# Access Compliance Report

## Public Rights-of-Way

### (Curb Ramps)

Intersection ID: 31212	Main Street: GRANTHAM_LN	Cross Street: WESTBURY_GLEN_CT	Location: NW
ADA ID: 4511F2A3161D	Ramp Type: Perp	Initial Pass/Fail: Fail	Overall Compliance: No
Severity Score: 25			
Codes/Mitigation Info/Possible Solution		Field Measurements/Component Compliance

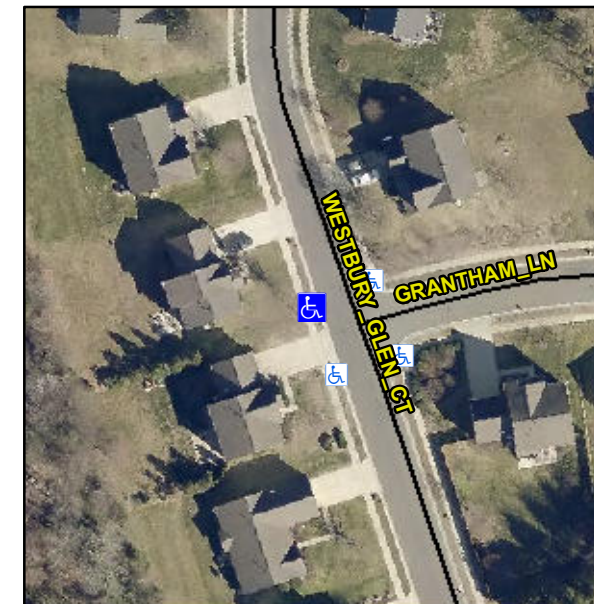
**Not Found, R304.2.2**

Compliance	Description	Data	Compliance	Description	Data
N/A	Ramp Length (in)	48.0	No	Ramp Slope (%)	15.7
Yes	Ramp Width (in)	49.0	Yes	Ramp XSlope (%)	0.1
N/A	Flare Type LT	N/A	N/A	Flare Type RT	N/A
N/A	Flare Slope LT (%)	N/A	N/A	Flare Slope RT (%)	N/A
N/A	Flare Traversable LT?	N/A	N/A	Flare Traversable RT?	N/A
N/A	Landing Length (in)	N/A	N/A	DWS Provided?	N/A
N/A	Landing Width (in)	N/A	N/A	DWS Contrast?	N/A
N/A	Landing Slope (%)	N/A	N/A	DWS Length (in)	N/A
N/A	Landing X Slope (%)	N/A	N/A	DWS Full Width?	N/A
N/A	Landing Curb? (Y/N)	N/A	N/A	DWS Offset (in)	N/A
N/A	Shared Landing?	N/A			
N/A	Gutter Ponding?	N/A	N/A	Gutter Slope (%)	N/A
N/A	Gutter Lip Ht (in)	N/A	N/A	Gutter X Slope (%)	N/A
N/A	Painted X Walk1?	No	N/A	Painted X Walk2?	N/A
	X Walk 1 Direction	To E		X Walk 2 Direction	N/A
N/A	X Walk 1 Width (in)	N/A	N/A	X Walk 2 Width (in)	N/A
	X Walk 1 Slope (%)	5.7		X Walk 2 Slope (%)	N/A
	X Walk 1 X Slope (%)	1.6		X Walk 2 X Slope (%)	N/A

**Remove & Replace Entire Ramp.**
